**CITY OF TEMPE  
DEVELOPMENT REVIEW COMMISSION**

Meeting Date: 08/09/2016  
Agenda Item: 5

**ACTION:** Request for a Development Plan Review of a new 2,888 square-foot restaurant and a Use Permit to allow a drive-thru lane for **JACK IN THE BOX**, located at 1350 West Broadway Road. The applicant is Looker & Cappello Architects.

**SITE PLAN**

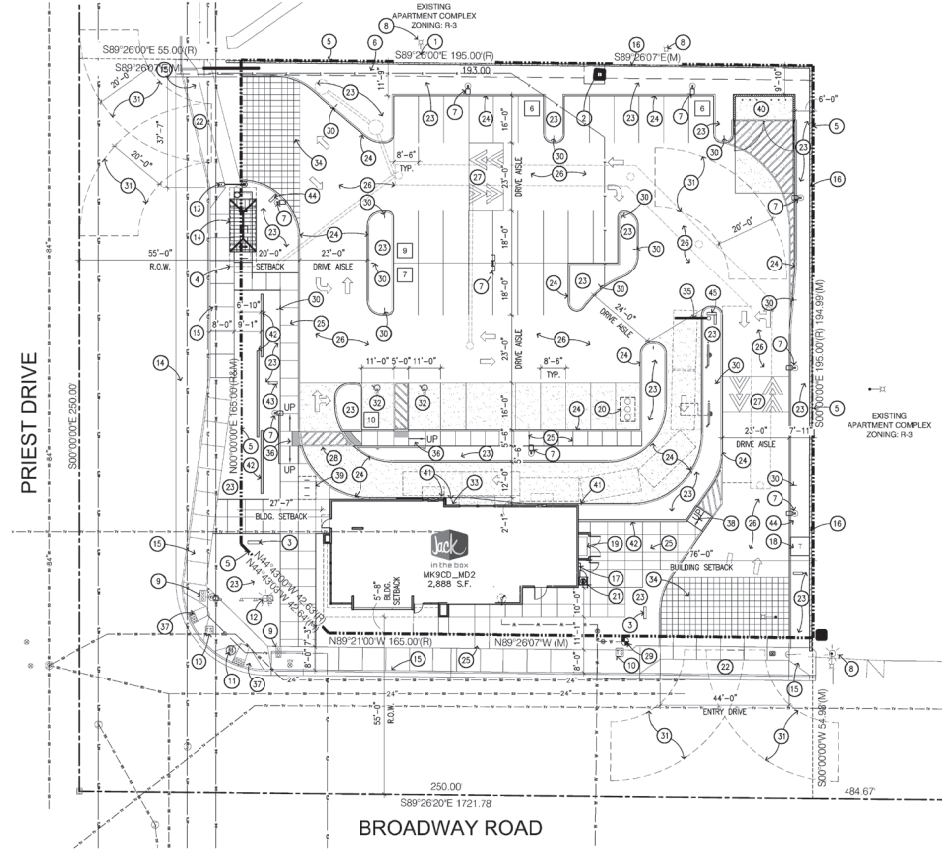
3. Provide a minimum of 39 vehicular parking spaces; or decrease building square footage to 2,887 square feet or less. If decrease in building square footage feasible then a parking analysis will need to be approved by the Planning Division prior to issuance of building permits.

4. Refuse enclosure and gates shall be finished and painted to match proposed building design.
5. Provide service yard and mechanical (cooling tower/generator) yard walls that are at least 8'-0" tall as measured from adjacent grade and are at least the height of the equipment being enclosed, whichever is greater. Verify height of equipment and mounting base to ensure that wall height is adequate to fully screen the equipment. Locate electrical service entrance sections inside the service yard, as indicated.

7. Provide upgraded paving at each driveway consisting of integral colored unit paving. Extend this paving in the driveway from the right-of-way line to 20'-0" on site and from curb to curb at the drive edges. From sidewalk to right-of-way line, extend concrete paving to match sidewalk.
